35/13-98D 18 West Irving Street (Chevy Chase Village Historic District)

Per your request the following describes the changes made to the 1998 approved HAWP application submitted for 18 West Irving Street. Chevy Chase.

HISTORIC PRESERVATION COMMISSION STAFF REPORT

PROPOSAL: Rear addition, new deck

PROPOSED SIDE ELEVATION $1/8^{\circ} = 1'-0''$ 2 OCTOBER 2002

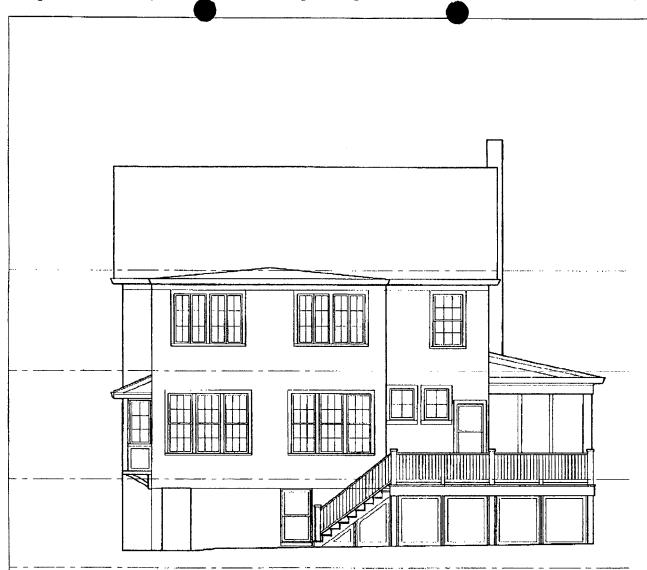
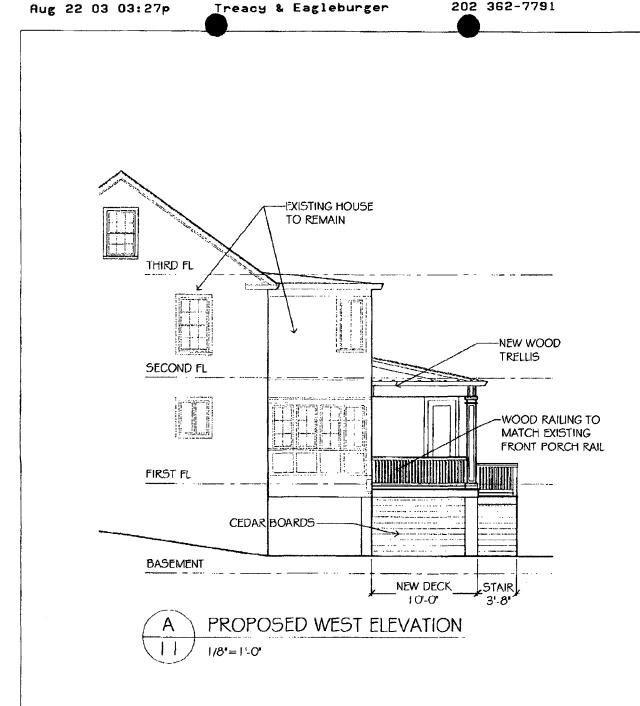
- 1. Window configuration: The two pairs of windows along the South and East Elevations have been reconfigured to three pairs of windows along the South wall and two pairs of windows and a 6' portion of wall along the East wall.
- 2. Basement Windows: An additional window has been added to the South wall at the lower level.
- 3. Wood Trellis: A wood trellis has been added to the new wood deck.

Here's this staff report, and you don't need to re-apply for a HAWP revision for the work at 18 W. Irving St. I would consider this in conformance with the HPC approval, and staff would just have to stamp your permit set before you go forward. Call this office, and ask for Corri Jimenez at 301-563-3404. Bring 3 permit sets with you, as one will remain in our office for our files. You take the other 2 to DPS for the building permit. -Robin Ziek

EAST ELEVATION - A 1/8" = 1'-0"

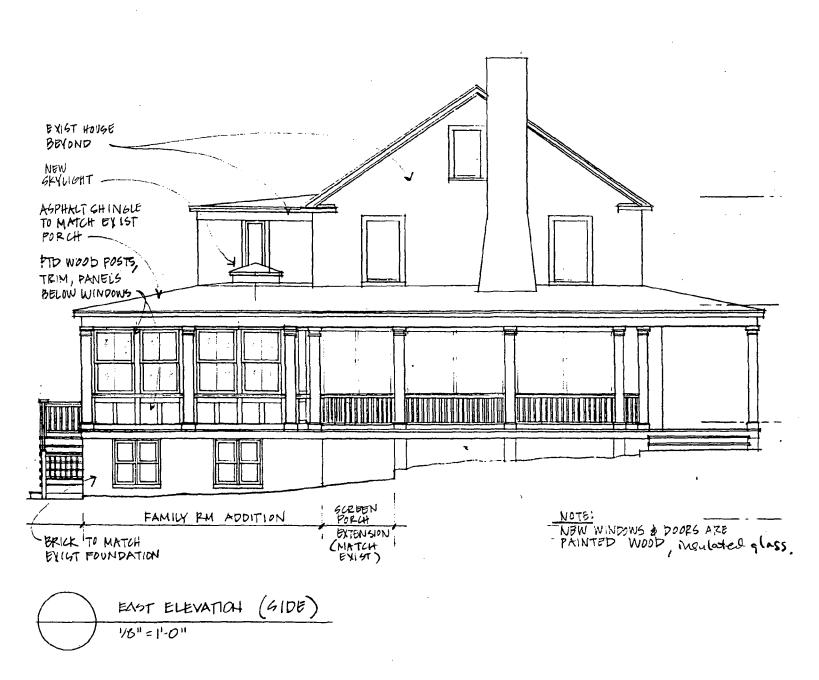
The new family room is designed as an extension of the existing porch. It has a hipped roof that continues the lines of the existing porch, and a skylight in the rear corner of the house (See Circle 5). The rhythm of the porch columns would continue along the extension of this rear addition, including the rear elevation. Instead of an open porch, the area between the columns would be enclosed with double-hung windows (2/2 fenestration proposed, with an alternate of 6/6 (see Circle $q_1/0$ and Circle 12,13). Instead of the open hand rail, the area beneath the windows

SOUTH ELEVATION - B 1/8" = 1'-0"

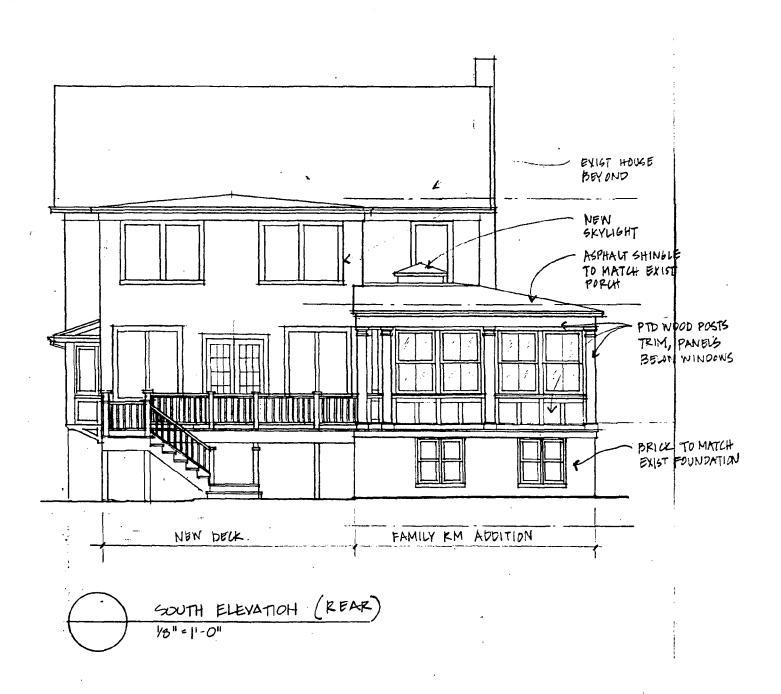
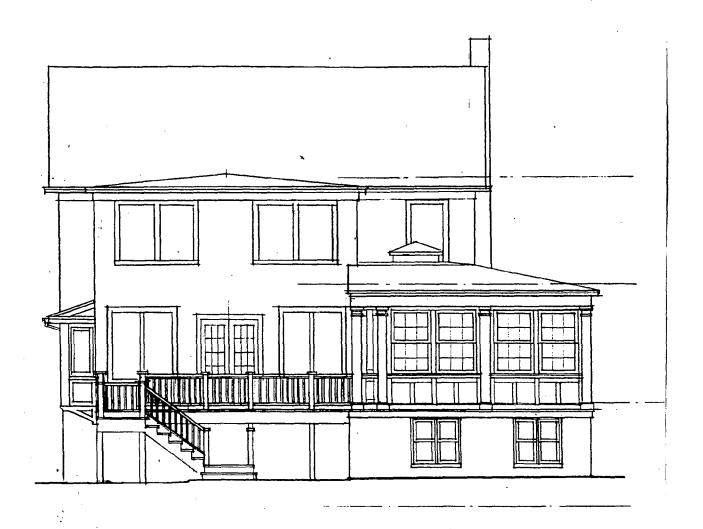
Two fenestration patterns have been offered for the rear addition. Staff recommends that the applicant use the 2/2 windows. This will help to differentiate the new addition from the main house which has 6/6 windows. In addition, the 2/2 windows provide a more open feel to the rear room, which will both complement the existing porch and reinforce the idea that the addition is actually an extension of the porch.

We further recommend that the applicant should be free to decide which of the two offered fenestration patterns to use, without being bound by the Staff's recommendation for 2/2 windows. We believe this latitude is appropriate for the following reasons. This is a proposed alteration to the rear of a contributing property. The Chevy Chase Village Guidelines, as amended by the County Council, state: "Alterations to the portions of a property that are not visible from the public right-of-way should be subject to very lenient review. Most changes to the rear of the properties should be approved as a matter of course." This application clearly merits approval under that standard, and there should be no restriction on the applicant's decision between the two offered fenestration patterns.
